DeKalb County Department of Planning & Sustainability

STAFF ANALYSIS

Case No.: CZ-22-1246090 **Agenda #:** N10

Request: A major modification to zoning conditions pursuant to CZ-20-1243972 to reduce the number of single-family detached lots from 19 to 6 lots.

SITE PLAN

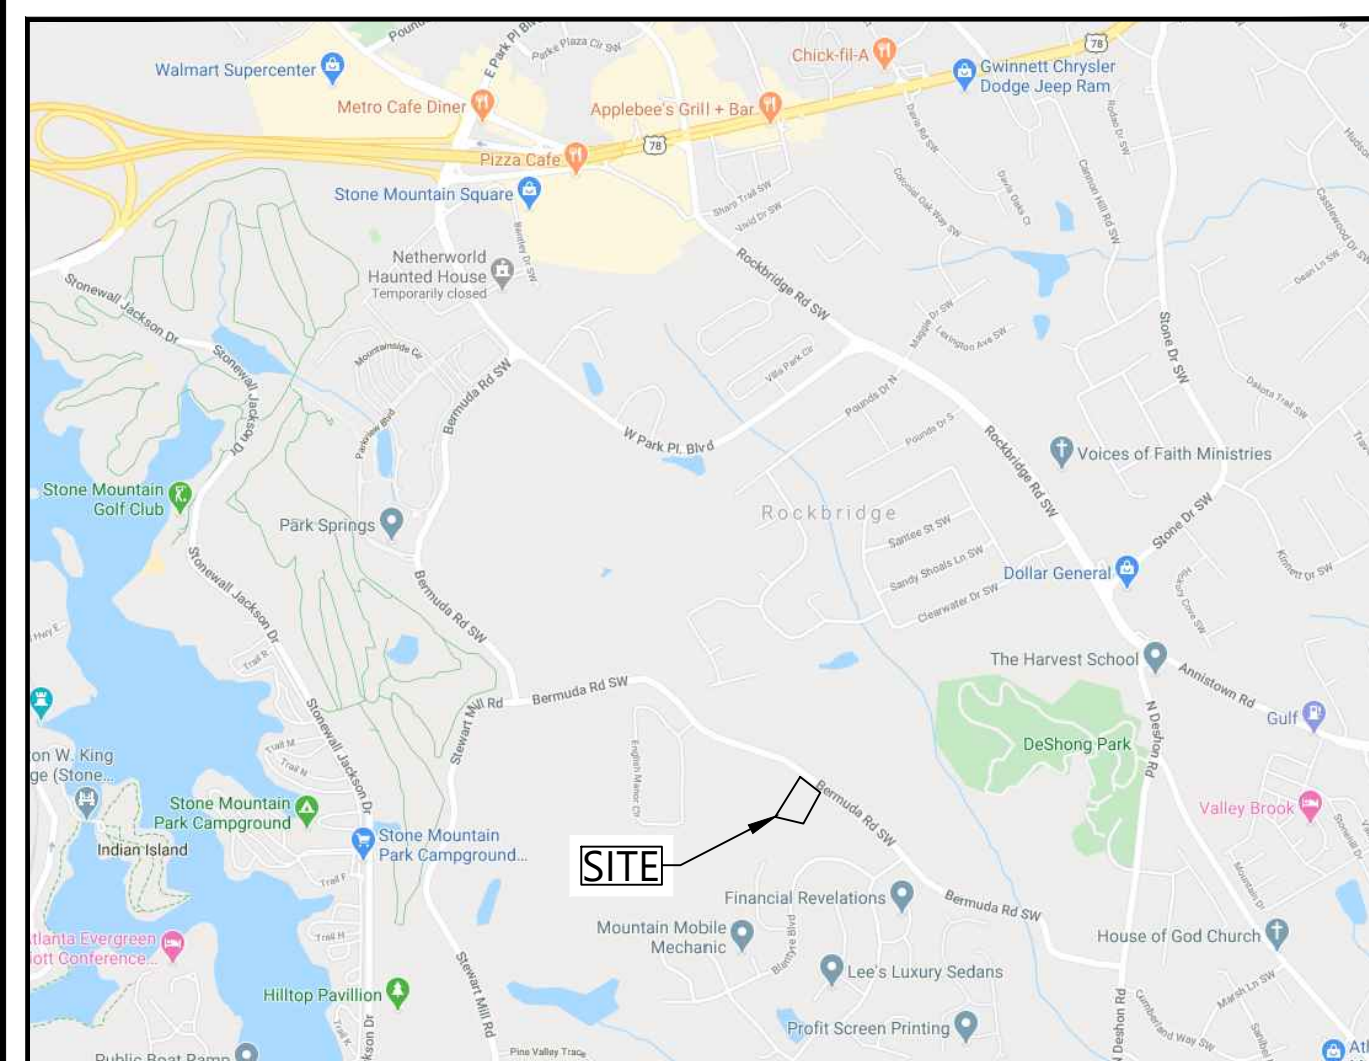
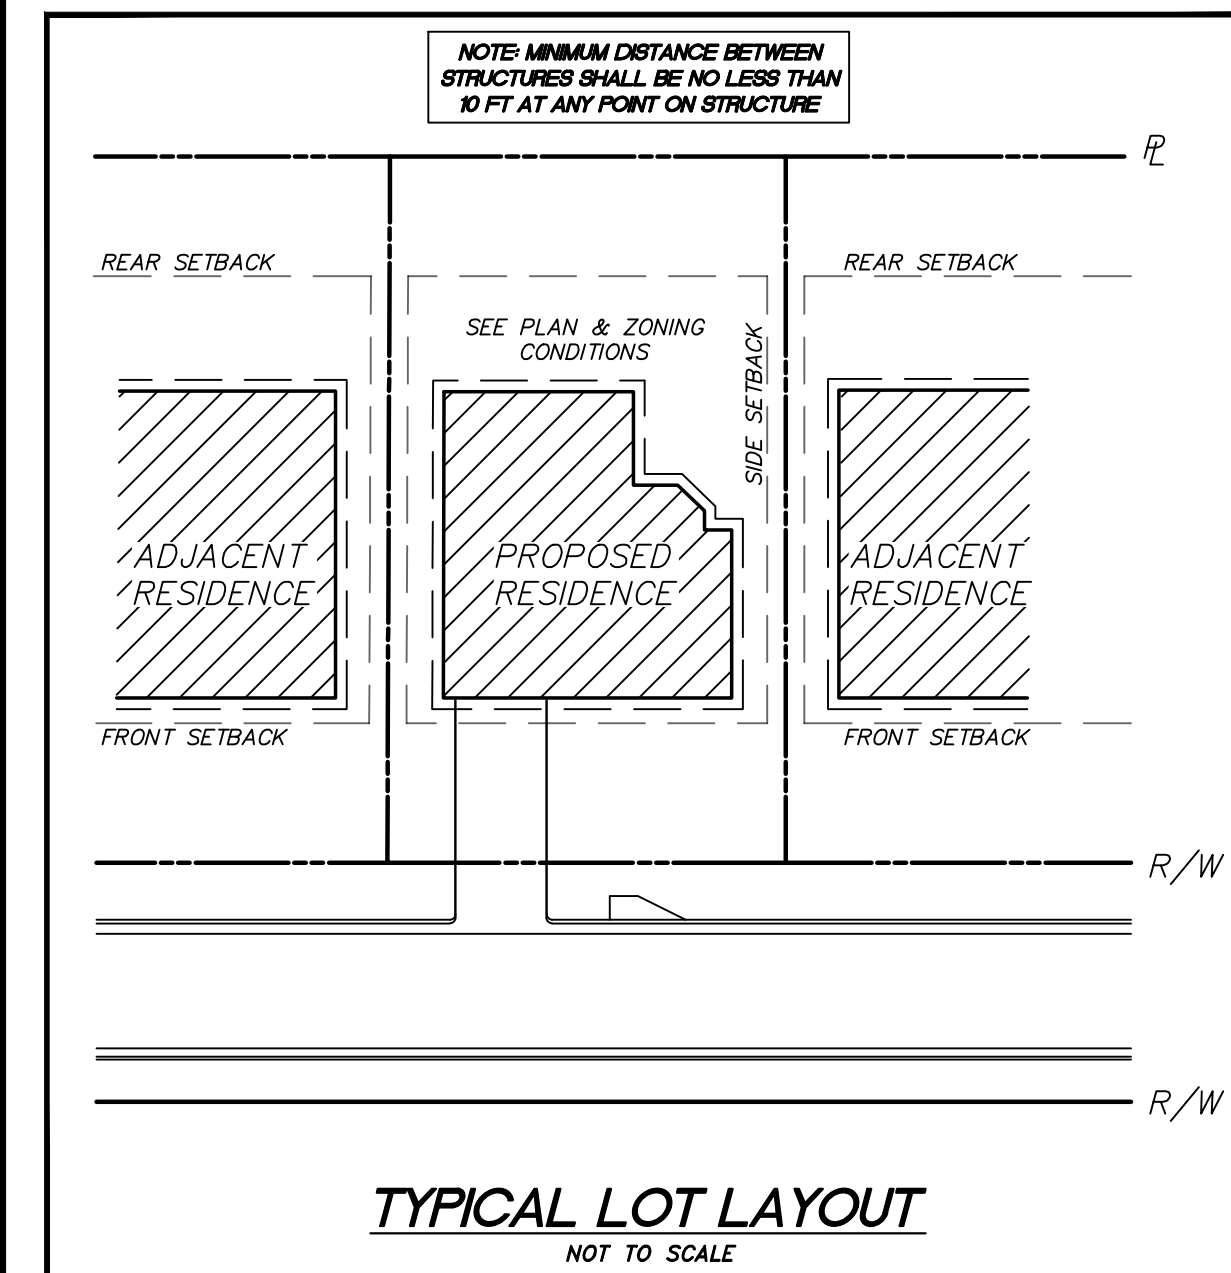
Notwithstanding these positive site plan features, the revised plan proposes a different access and building orientation scenario than what was originally approved. The previously approved plan provided access to all the homes via a new public street with all units facing the interior of the project site, while the proposed plan provides access via a shared access driveway with all units fronting along and facing Bermuda Road (see attached). The Planning Department would prefer that the shared access driveway be relocated behind the proposed homes so that the garages would not be visible to the motoring public along Bermuda Road. The applicant has indicated that while that design scenario would be ideal, the steep topography of the site would prevent that from being implemented. However, the applicant indicates that the project will comply with the Bermuda Road landscaping condition that was previously adopted with the original RSM zoning approval (see Condition #15) which should hide the proposed garages from view as much as possible. The Zoning Board of Appeals (ZBA) will be required to review the proposed shared driveway on its merits since Sec. 5.7.5.F.2 of the Zoning Ordinance allows a maximum of two lots to share the same driveway and the plan shows shared driveway access to six lots.

More information is needed to verify compliance with stormwater management regulations. The Land Development Division indicates that the conceptual plan doesn't indicate the location of the stormwater management facility. The Land Development Division strongly recommends that a design professional investigate the site and identify location where runoff Run-off Reduction Volume (RRV) can be provided and re-design/revise the layout to comply with the RRV requirement (see attached interdepartmental comments from Land Development Division).

Conceptual plan doesn't indicate the location of the stormwater management facility. Location of stormwater management shall be shown or compliance with the County stormwater management regulations shall be explained.

- N10. 1347 Bermuda Road.** By Code- shared driveways can only be for 2 lots. A variance will be necessary to have 6 lots on a shared driveway. Suggestion: widen to 24 feet and make it a private road. Bermuda Road is classified as a collector road. requires a right of way dedication of 35 from centerline OR such that all public infrastructure is within right of way, whichever greater. Requires a 5 foot landscape strip with a 10 foot mulituse path. No poles may remain within the limits of the path. Requires pedestrian scale streetlights. Watch minimum separation of drives/roads in section 14-200(6) based on the speed limit of the road.

Possible Variances: Proposed shared drive will be reviewed to verify compliance with Transportation Department and Zoning Ordinance requirements. From a conceptual standpoint Planning Department would prefer the access drive to provide access to the rear of the proposed lots. Show compliance with RSM requirements including but not limited to minimum lot area and lot width, required parking, parking lot landscaping, minimum open space, maximum building height, transitional buffers, streetscape improvements (sidewalks/street trees/street lighting), building materials, outdoor lighting, etc. The applicant is encouraged to discuss possible transportation improvements that may be required (if the rezoning is approved by the Board of Commissioners) with the county Transportation Department. The applicant is encouraged to contact Land Development Division of Public Works regarding required storm water management, floodplain, and stream

Therefore, it is the recommendation of the Planning & Sustainability Department that the request be "*Deferred Full Cycle*" to allow the applicant time to address the stormwater management regulations and re-design or revise the plan as needed to comply. Should the Board decide to approve the request, Planning Staff recommends the following conditions (additions from the previously approved zoning conditions are in **blue bold**, and proposed deletions are in ~~red strikethrough~~).
